United States Department of the Interior

Re: Minor Modification of Resource Recovery and Protection Plan (R2P2), 8th Right Longwall, Hiawatha Seam, Deer Creek Mine.

DEER CREEK MINE
8th Right Longwall - Proposed
and Proposed Setup Locations

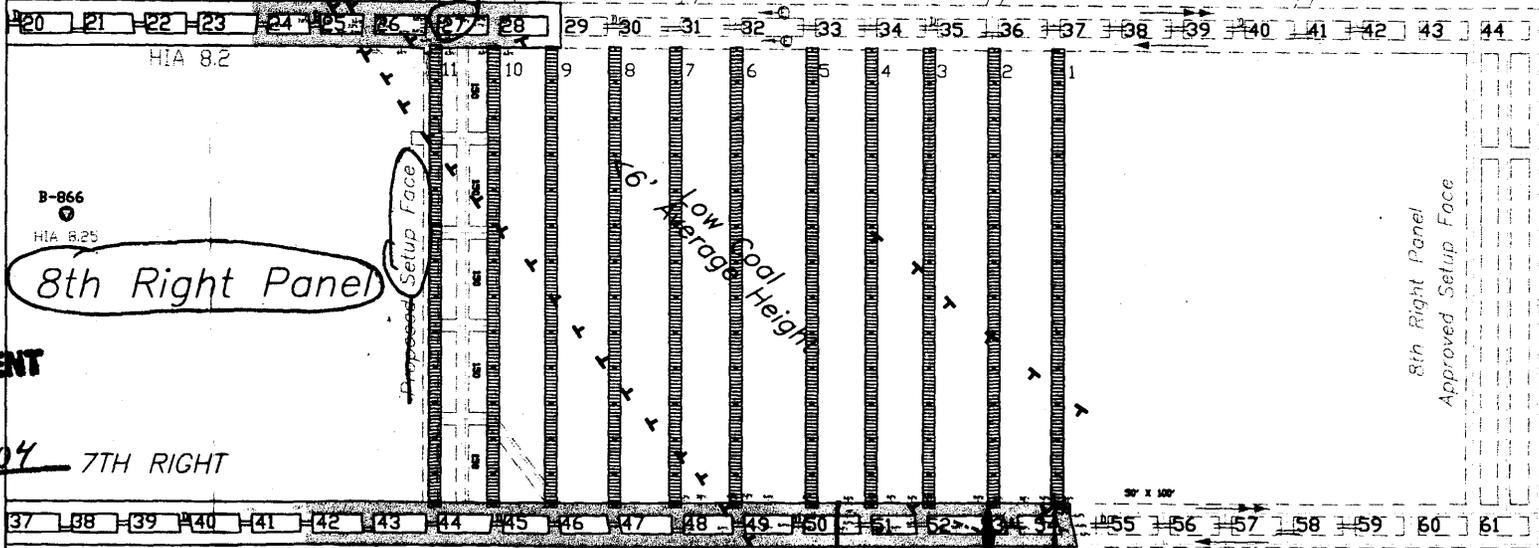
Interwest proposed to halt development of the 8th Right gate entries and mine the longwall set up and bleeder entries at crosscut #27 of the 8th Right gate entries and connect up to crosscut # 44 of 7th Right. The 8th Right longwall panel will be shortened by about 1600 feet from the original projected panel. Interwest reported that the 8th Right gate development miner has encountered a fluvial channel scour system that has reduced coal height to less than 6 feet. The channel system has similar features and orientation of the channel system encountered in 7th Right at crosscut 54. Interwest projects this low coal in this channel system through the panel at a NW-SE direction. Coal face profiles taken in the gate entries and projected through the panel show an estimated +20% ash product if the longwall should mine through this area. Unacceptable coal quality and the inability to access acceptable quality coal from this area are Interwest's justifications to cut the longwall panel short.

The BLM evaluated the submission, inspected, and documented the 8th Right conditions and agrees with the proposal to change the set-up entry location. BLM provided a verbal approval for the modification on 4 December 2003. Coal heights and mining conditions were noted and verified. Also, Interwest provided manufacture's specifications of the longwall system machinery that limits the minable seam height. The information submitted indicates that the channel system, with a high potential for low coal from scouring and with a sandstone roof and floor, has negated longwall coal recovery past crosscut #24 in 8th Right.

The modification of the R2P2 complies with the Mineral Leasing Act of 1920, as amended, the regulations at 3480, and the lease terms and conditions and will achieve maximum economic recovery of the federal coal. The modification to mine the 8th Right longwall set up rooms at crosscut #24 and extract the remainder of the panel is approved as submitted. This confirms verbal approval given earlier. A copy of the approved mine map is enclosed. If you have any questions, please contact Stephen Falk at the Price Field Office (435) 636-3605 or Jeff McKenzie of my staff at (801) 539-4038.
